# CONSTRUCTION PLANS

## FOR

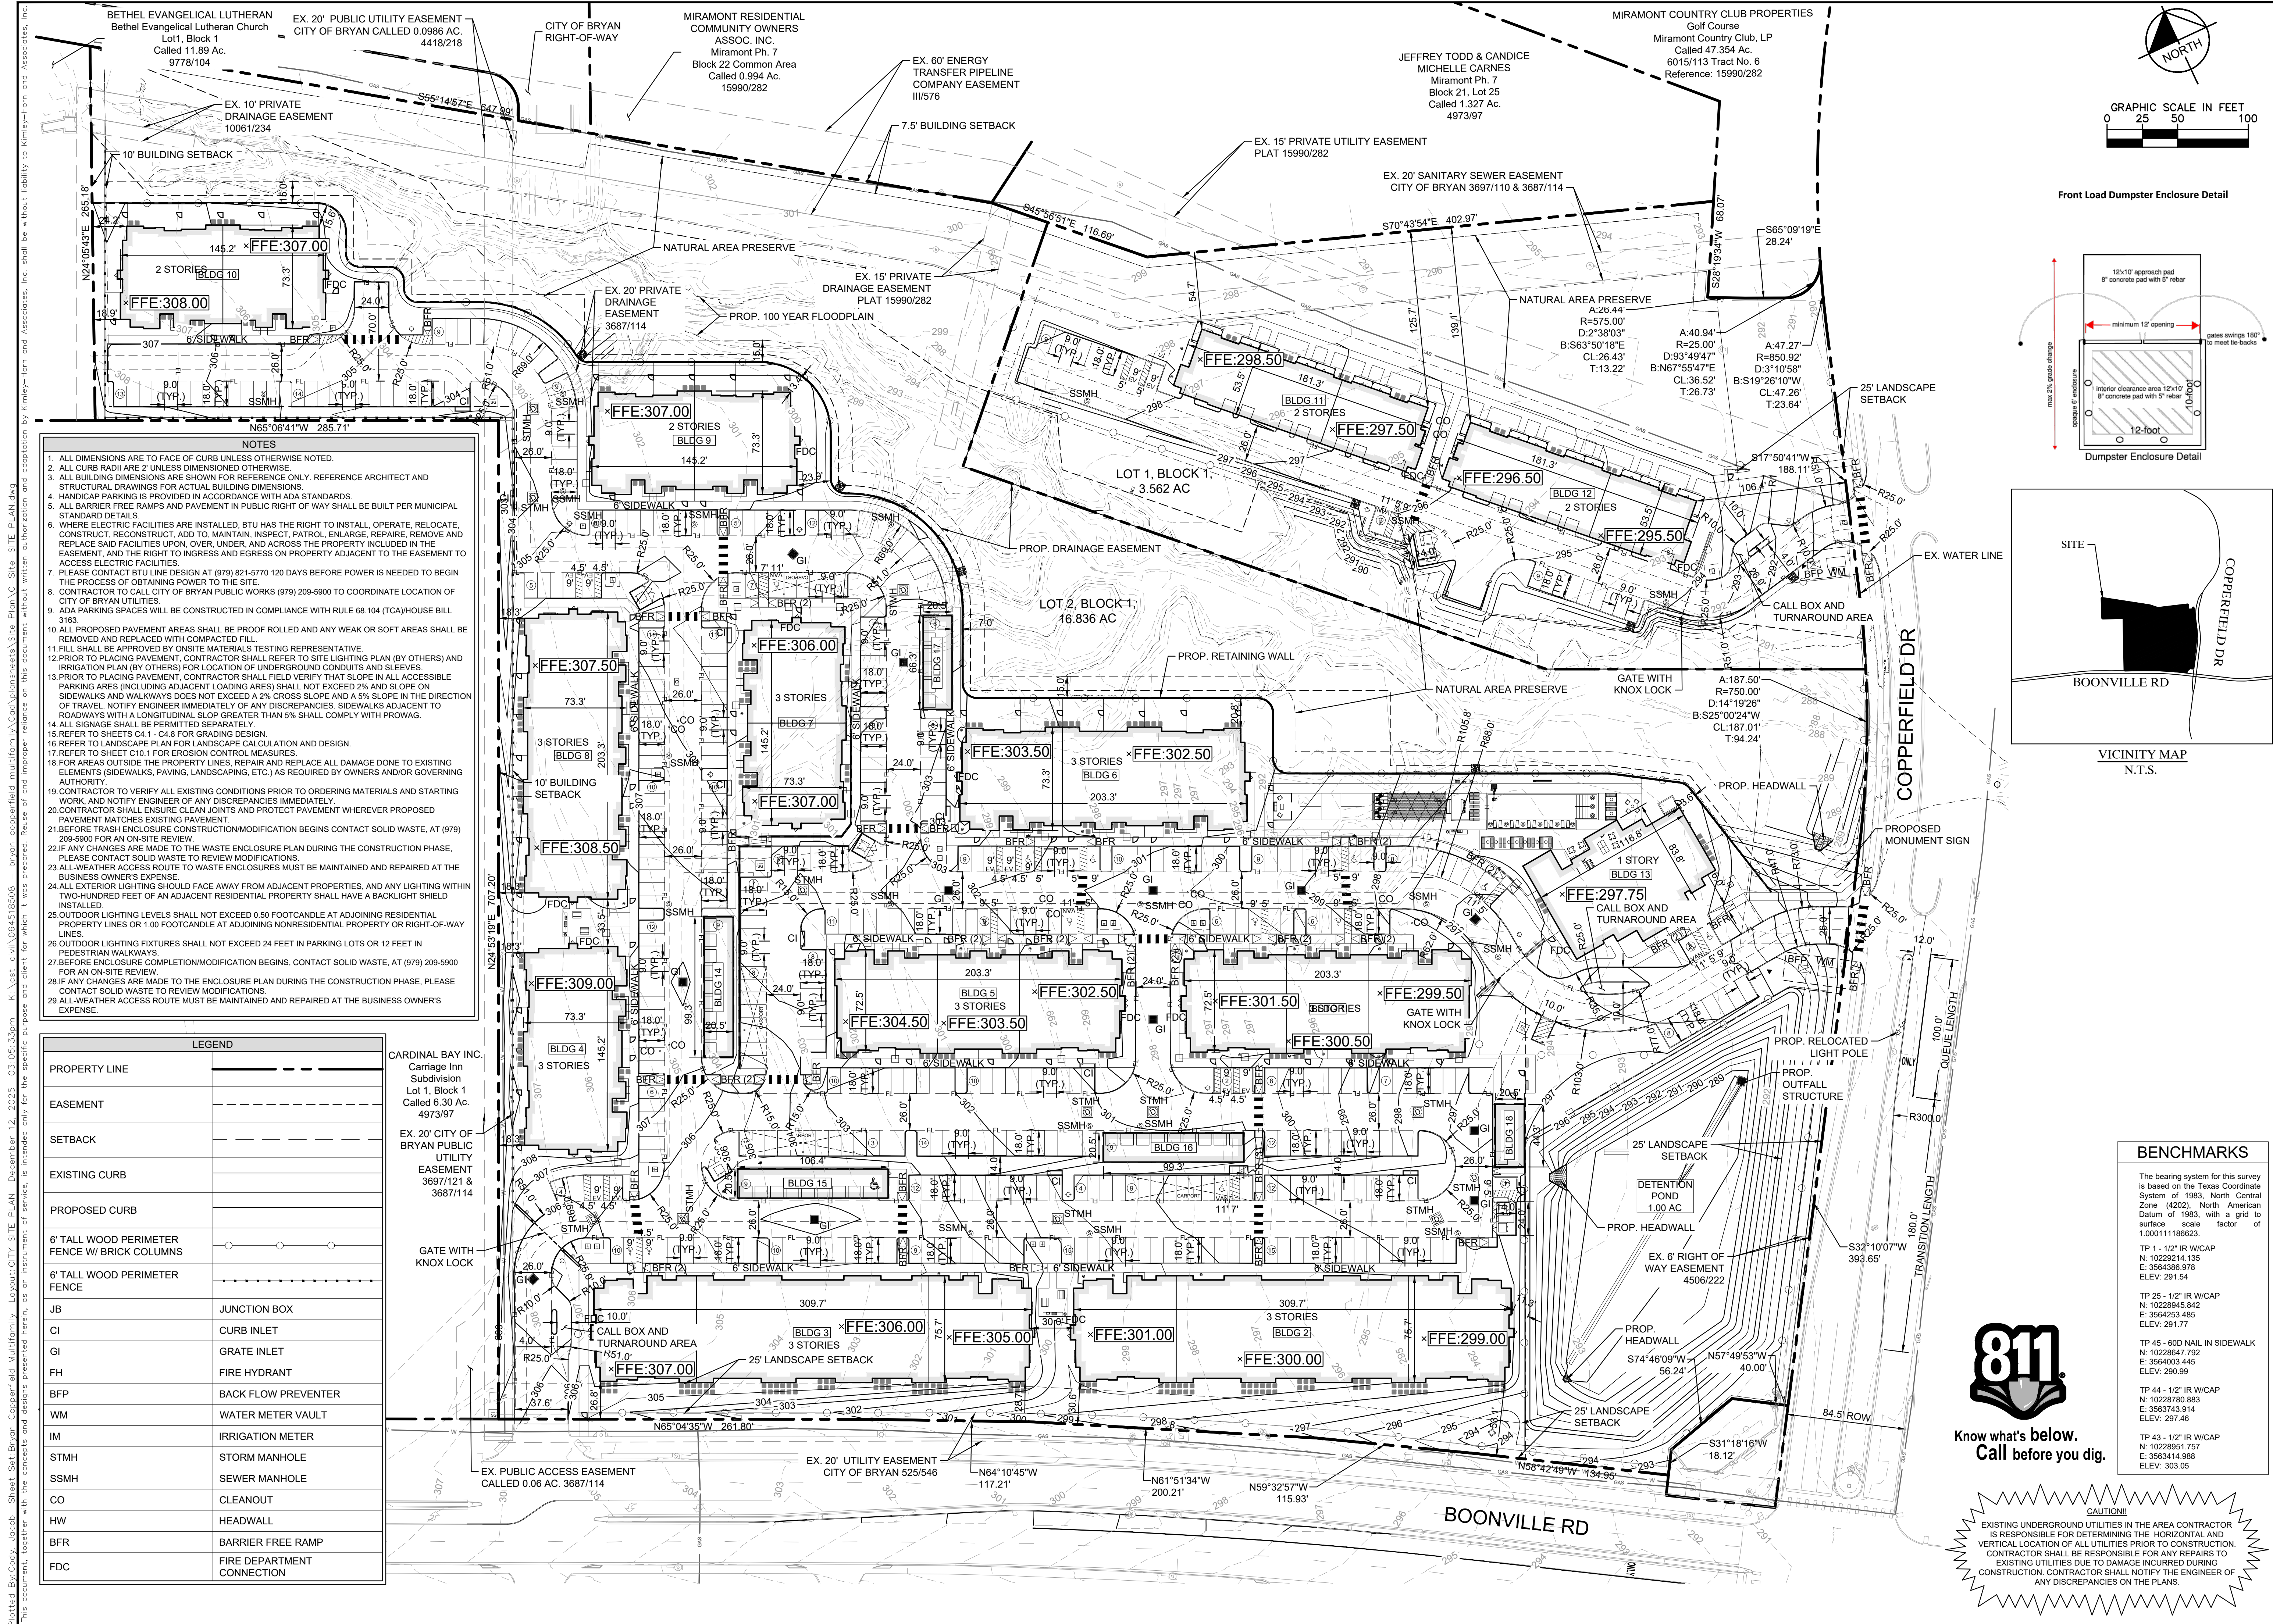
**KH GENERAL NOTES**  
**OVERALL:**  
1. ALL CONSTRUCTION AND MATERIALS SHALL BE IN ACCORDANCE WITH THESE PLANS, CITY (OR TOWN) STANDARD DETAILS AND SPECIFICATIONS, THE FINAL GEOTECHNICAL REPORT AND ALL ISSUED ADDENDA, AND COMMONLY ACCEPTED CONSTRUCTION STANDARDS. THE CITY SPECIFICATIONS SHALL GOVERN WHERE OTHER SPECIFICATIONS DO NOT EXIST. IN CASE OF CONFLICTING SPECIFICATIONS OR DETAILS, THE MORE RESTRICTIVE SPECIFICATION AND STANDARD SHALL BE FOLLOWED.
